Thanbee Print World Ltd. and Parkway Packaging & Printing PLC

Sardagonj, Kashimpur, Gazipur-1349
(23.978112, 90.304102)
20 August 2025

Structural Inspection Report

Observation 01: Incomplete design report [Building 1: Production Building (Block-A)]

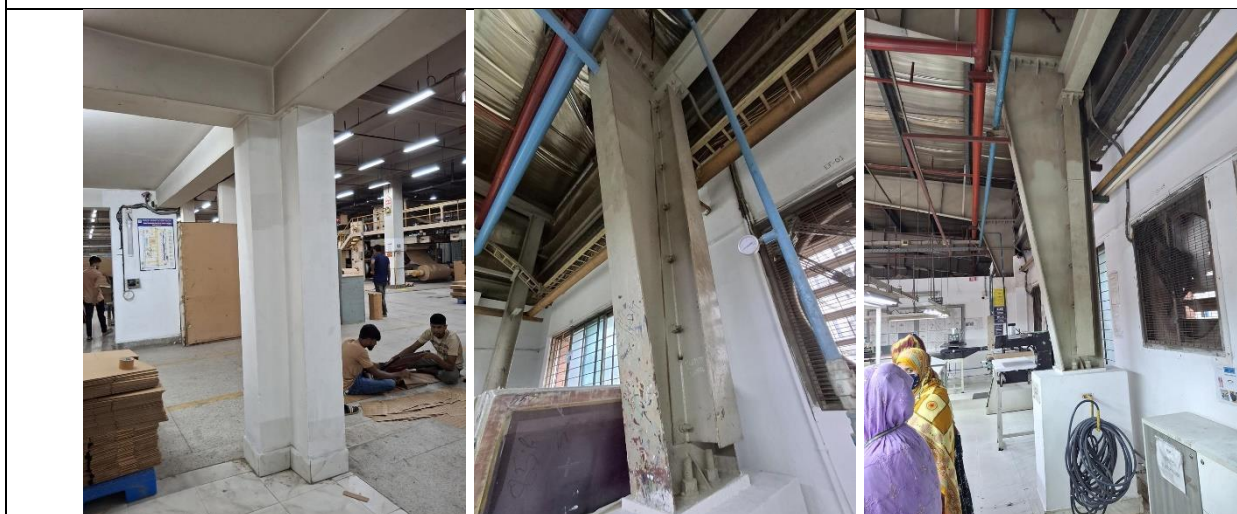
Description: A design report was available onsite. The design report did not cover all the adequacy checks as per BNBC 1.9.1. The building engineer is required to revise the design report following BNBC 1.9.1 based on as-built member sizes & in-situ material strength and submit to RSC for detailed review against lateral forces.

Observation 02: Mismatch/lack of as-built drawing [Building 1: Production Building (Block-A)]

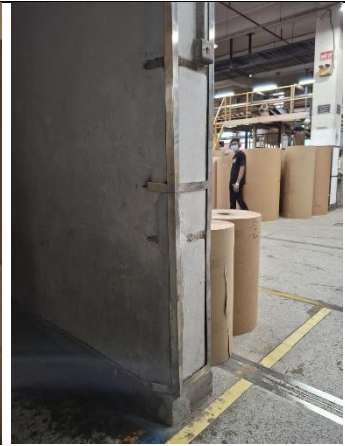
Description: L-shaped column found below mezzanine floor instead rectangular column, portal bracing details not provided in the drawings, and a RC column found around 2.1 m high on the 2nd floor, where the drawing shows 1 m for all typical RC columns. The building engineer is required to survey the structure and prepare accurate as-built drawings with all necessary connection details.

Observation 03: Forklift impact on beam and surface damage [Building 1: Production Building (Block-A)]

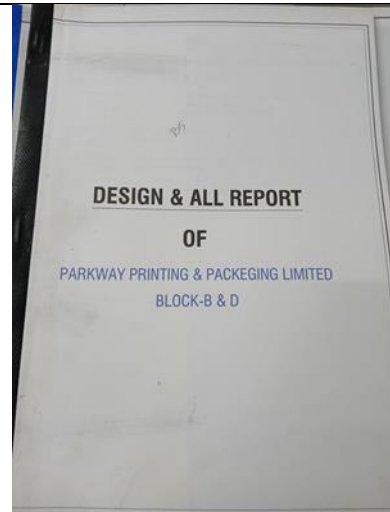
Description: Beam damage was found due to the impact of forklifts. Also, a sign of impact was observed on columns. Repair the damage to the beam and take precautionary measures to prevent further impact.

Observation 04: Inconsistencies in the EA report (Building-2: OFFICE BUILDING WITH WTP & GENERATOR (BLOCK-B & D))

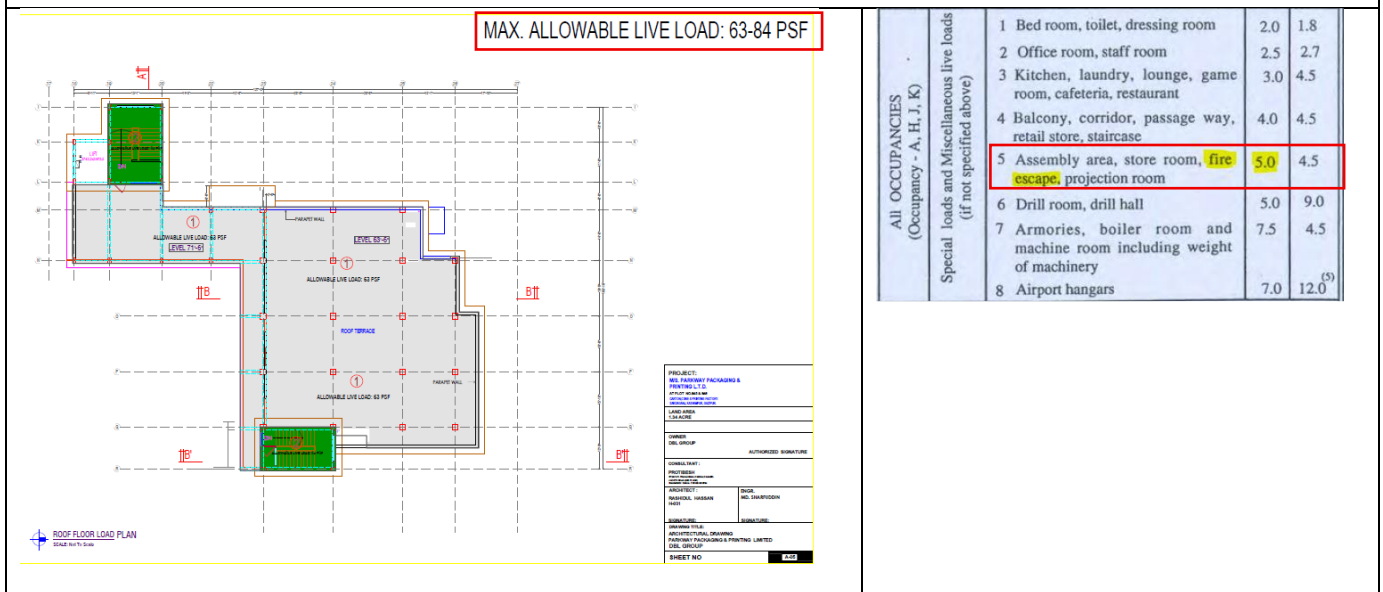
Description: The response modification coefficient (R value) was considered as 8 for IMRF; however, no calculation or justification was provided. Moreover, no irregularity check was provided. The building engineer is required to address the inconsistencies in the revised EA report and submit the revised EA to RSC.

Observation-05: Load plan does not comply with BNBC requirements (Building-2: OFFICE BUILDING WITH WTP & GENERATOR (BLOCK-B & D))

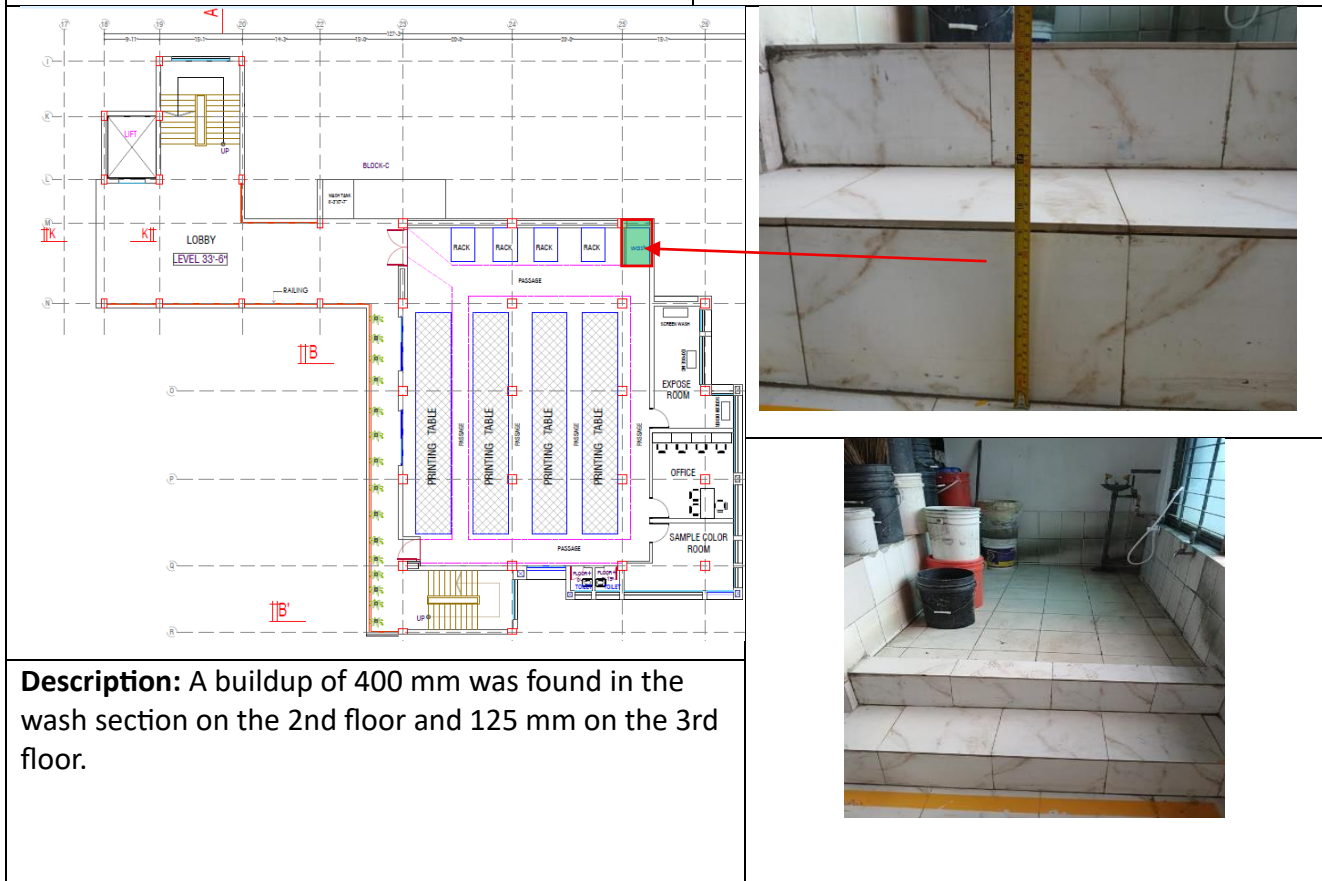
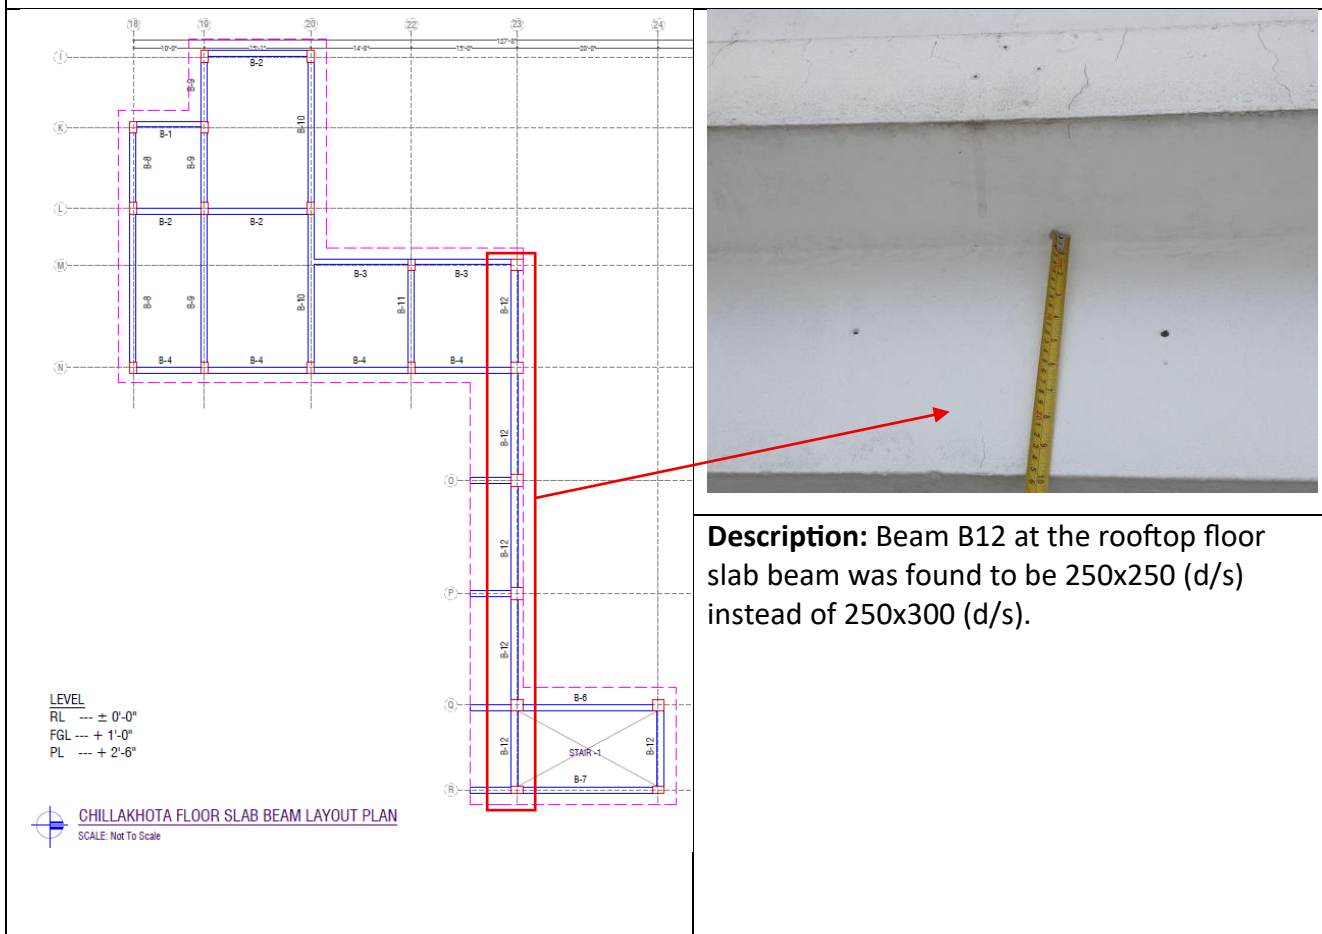
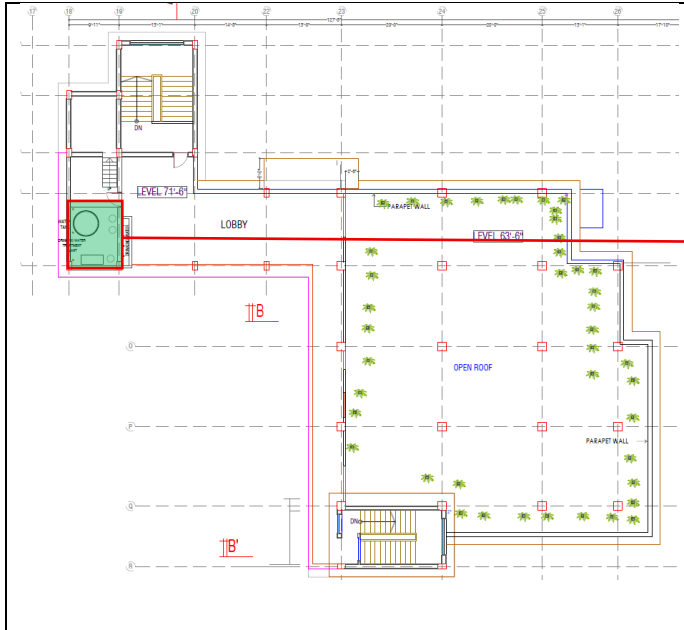
Description: There are two staircases in the building. According to BNBC, the minimum floor live load for staircases used as fire escapes is 5.0 kN/m². However, the stairs have been designed for a live load of only 4.0 kN/m² (84 psf).

The building engineer is required to revise the load plan and associated design documents to ensure compliance with BNBC requirements.

Observation 09: Inconsistencies in the EA report. (Building-3: Utility Building (BLOCK-C))

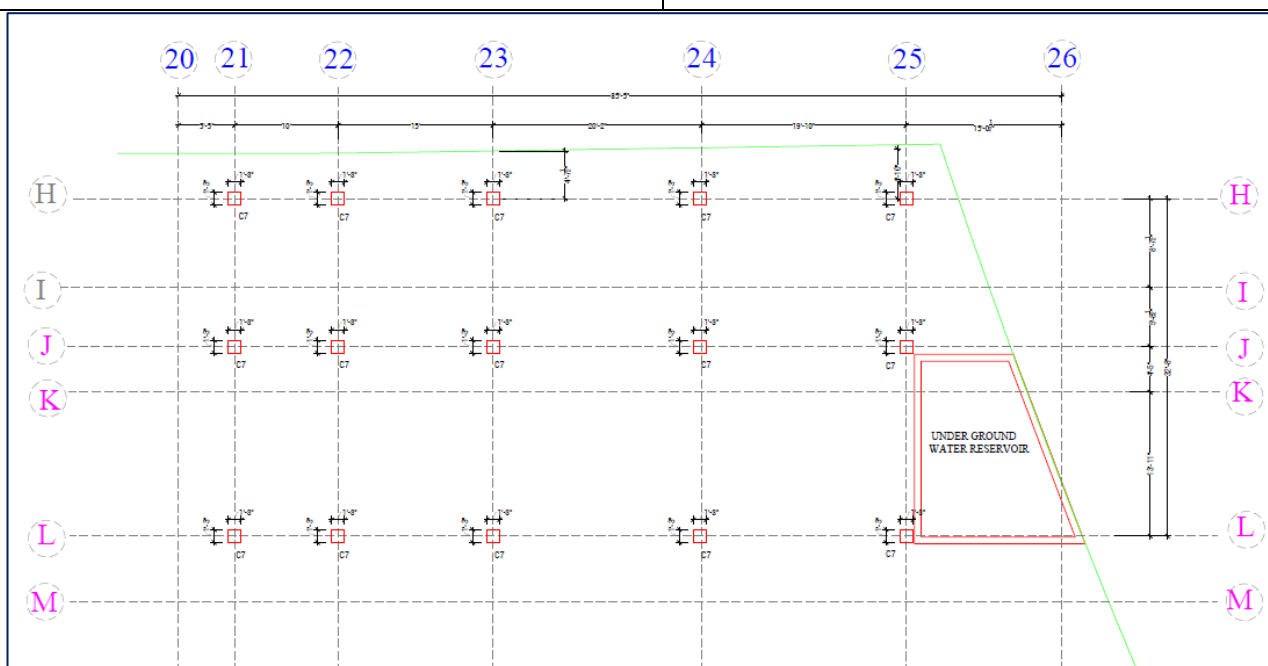
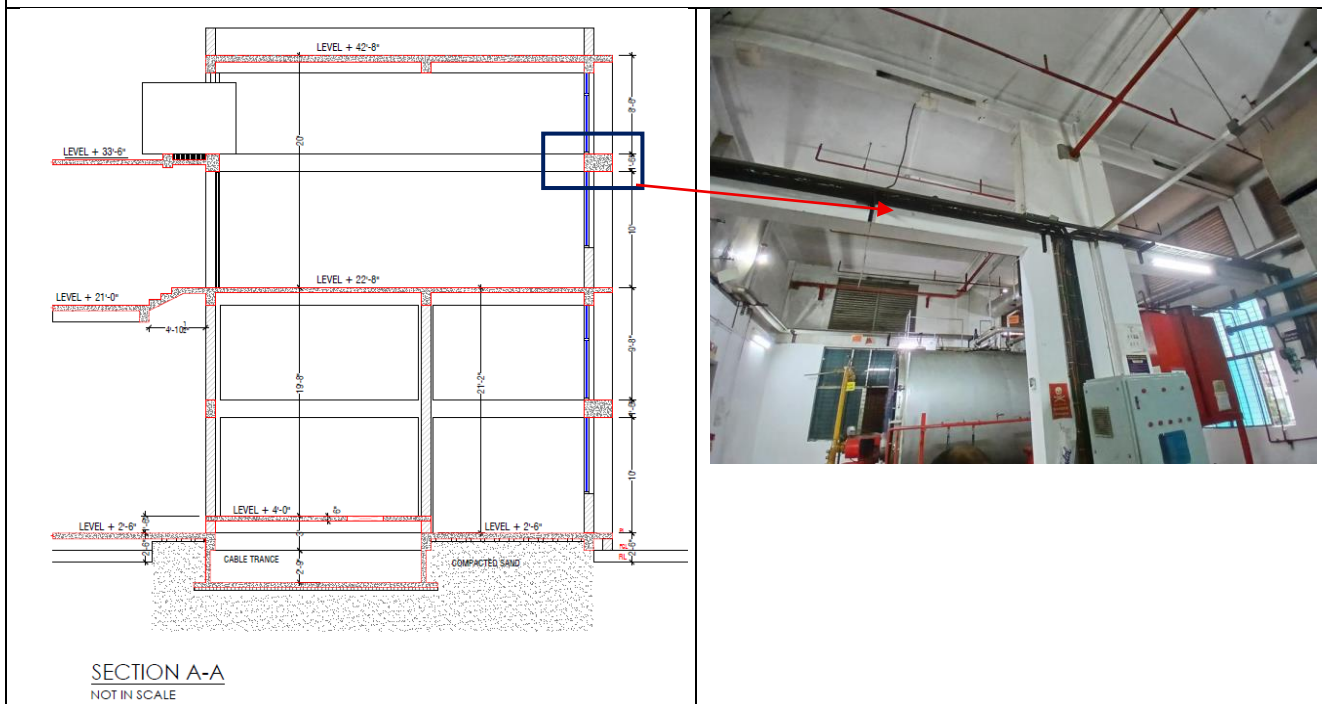
Description: In the EA report, the column and foundation adequacy checks do not match the column sizes and IDs shown in the as-built drawings.

The building engineer is required to address the inconsistencies in the revised EA report and submit the revised EA to RSC.

Observation 11: Lack of as-built drawings (Building-5 & Building-12)

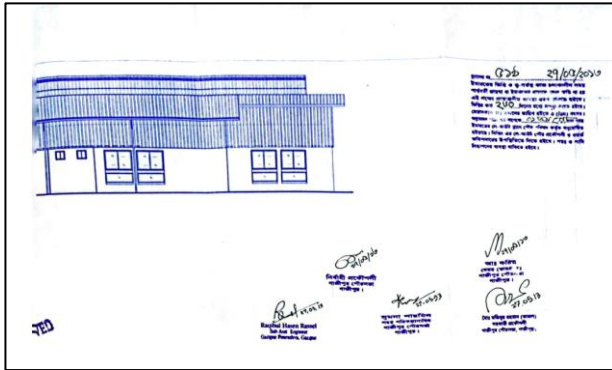
Description: As-built structural & architectural drawings were not available for those structures. The building engineer is required to survey the structures and prepare as-built drawings, including foundation details, and necessary connection information.

Observation 17: Trolley impact on column. (Building-7: Storage Shed-2)

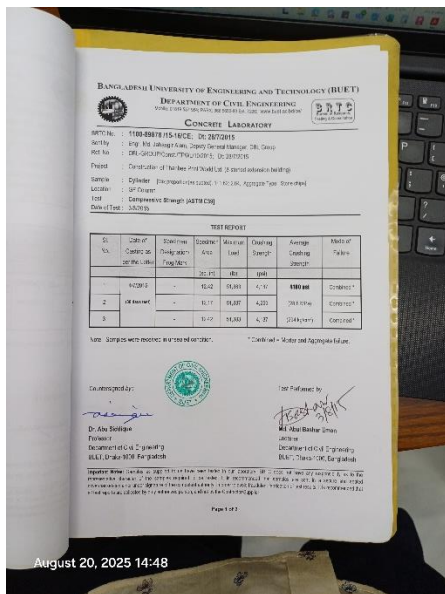
Description: During inspection, several impacts were found on the RC column. The building engineer is required to provide a column guard around the column to avoid trolley impact.

Observation 23: The design report needs to be revised. (Building-10: ETP Building)

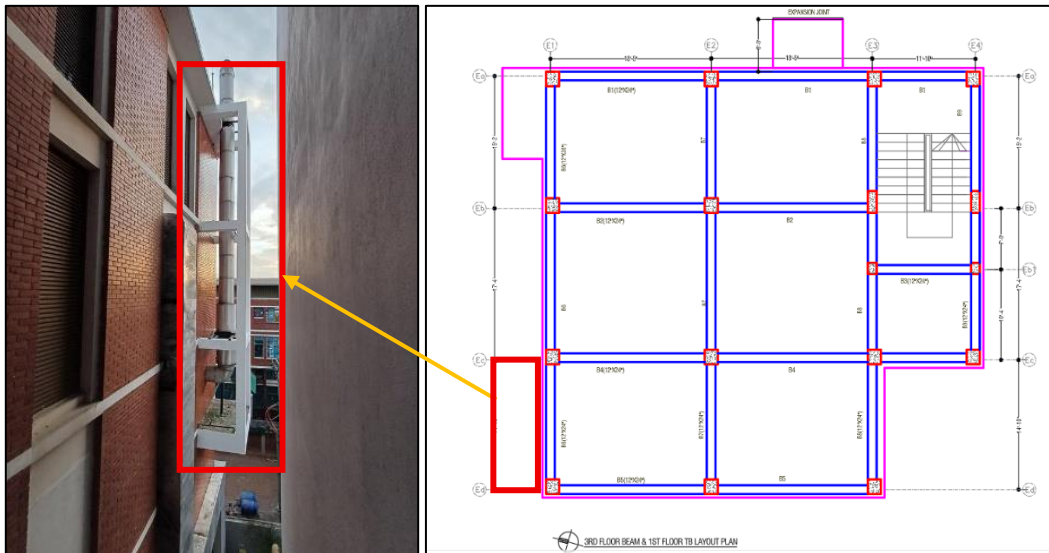
Description: The Response modification coefficient R value was considered 8.0 (SMRF) for the building, but no justification was provided. The building engineer is required to revise the design report and submit it to RSC for review.
